SERVICE LETTER 404

SUBJECT: Aileron Hinges

APPLICABLE MODELS: All 7 Series Aircraft with 1000+ Hours

FIG. 1

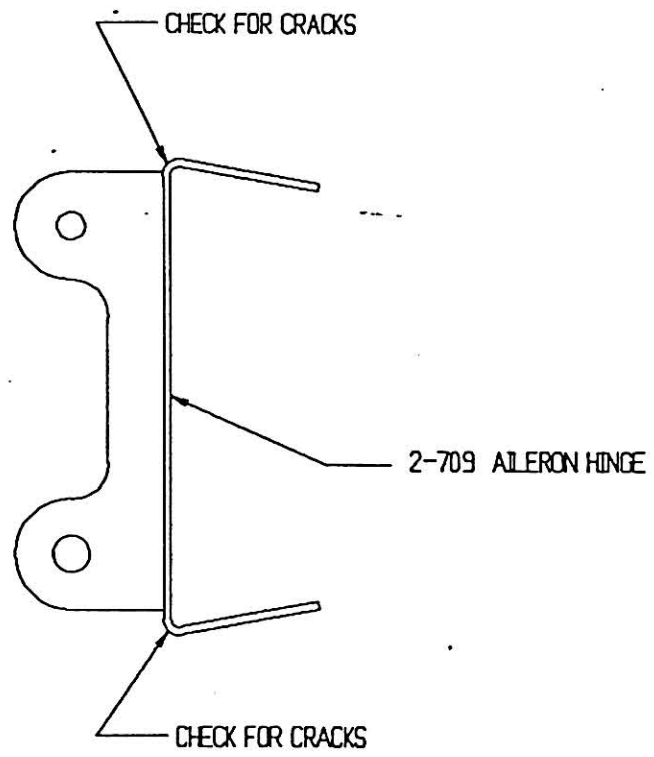
DESCRIPTION: There have been reports of cracks on the inboard aileron hinges, part number 2-709, used on all of the 7 series aircraft. These reports state that cracks are being found at either tab end of the most inboard aileron control hinge. The cracks appear on the outside bend radius of the upper and lower tabs. There have also been reports of tab failure.

- 1.) Before further flight, perform a visual inspection of the aileron hinges for evidence of cracks (see fig. 1). This will require the removal of a small amount of fabric in the hinge area.
- 2.) If the cracks are found, replace the hinge with part number 2-709.
- 3.) If no cracks are found, inspect the hinge at each annual or every 100 hours.

COMPLIANCE: Before further flight and every 100 hours thereafter.
